Access Compliance Report

Public Rights-of-Way

(Curb Ramps)

Intersection ID: 23815	Main Street: CARMEL_RD	Cross Street: MONTIBELLO_DR	Location: NW
ADA ID: 5DAB6AB9D244	Ramp Type: PerpDiag	Initial Pass/Fail: Fail	Overall Compliance: No
		Severity Score: 10

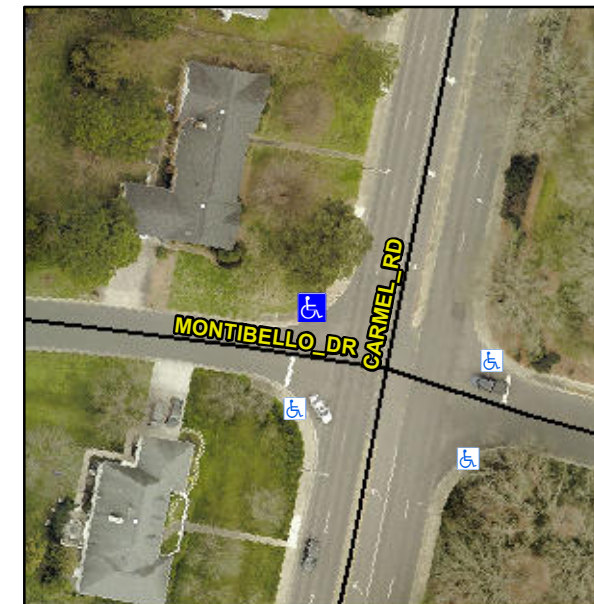
Not Found, R304.5.1, R304.5.3

Compliance	Description	Data	Compliance	Description	Data
N/A	Ramp Length (in)	58.0	Yes	Ramp Slope (%)	6.4
No	Ramp Width (in)	43.0	No	Ramp XSlope (%)	3.2
N/A	Flare Type LT	N/A	N/A	Flare Type RT	N/A
N/A	Flare Slope LT (%)	N/A	N/A	Flare Slope RT (%)	N/A
N/A	Flare Traversable LT?	N/A	N/A	Flare Traversable RT?	N/A
N/A	Landing Length (in)	N/A	N/A	DWS Provided?	N/A
N/A	Landing Width (in)	N/A	N/A	DWS Contrast?	N/A
N/A	Landing Slope (%)	N/A	N/A	DWS Length (in)	N/A
N/A	Landing X Slope (%)	N/A	N/A	DWS Full Width?	N/A
N/A	Landing Curb? (Y/N)	N/A	N/A	DWS Offset (in)	N/A
N/A	Shared Landing?	N/A			
N/A	Gutter Ponding?	N/A	N/A	Gutter Slope (%)	N/A
N/A	Gutter Lip Ht (in)	N/A	N/A	Gutter X Slope (%)	N/A
N/A	Painted X Walk1?	No	N/A	Painted X Walk2?	No
	X Walk 1 Direction	To S		X Walk 2 Direction	To SE
N/A	X Walk 1 Width (in)	N/A	N/A	X Walk 2 Width (in)	N/A
	X Walk 1 Slope (%)	2.3		X Walk 2 Slope (%)	3.9
	X Walk 1 X Slope (%)	2.8		X Walk 2 X Slope (%)	1.5

Remove & Replace Curb Ramp With Two New Directional Ramps or Equivalent.
